ADDENDUM NO. 2

Project: First United Methodist Church

Project No.: L09064.fum

Date: November 8, 2011

1 REFLECTED CEILING PLAN - FIRST FLOOR
1/8" = 1'-0"

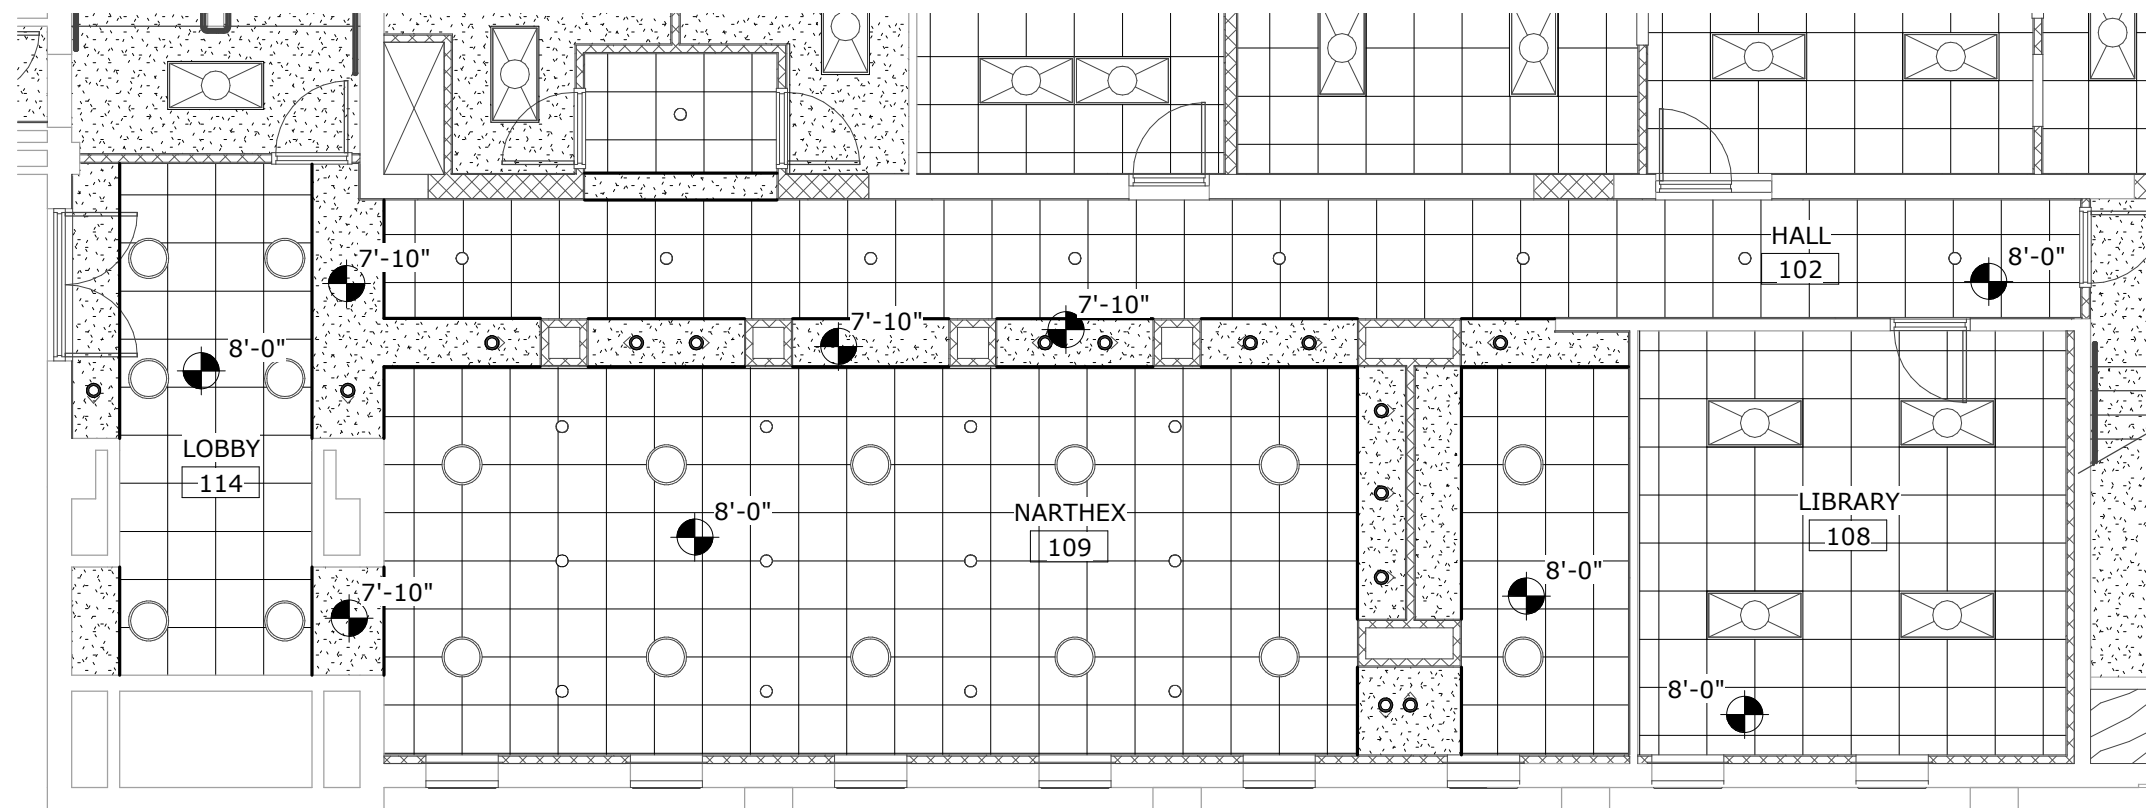
1. **Section 095100 – Acoustical Ceilings:** Replace 'ACT-1' Hunter Douglas Ceiling with 'ACT-2' 2'-0" X 2'-0" Acoustical Ceiling Tile. See revised ceiling layout on attached sheet.
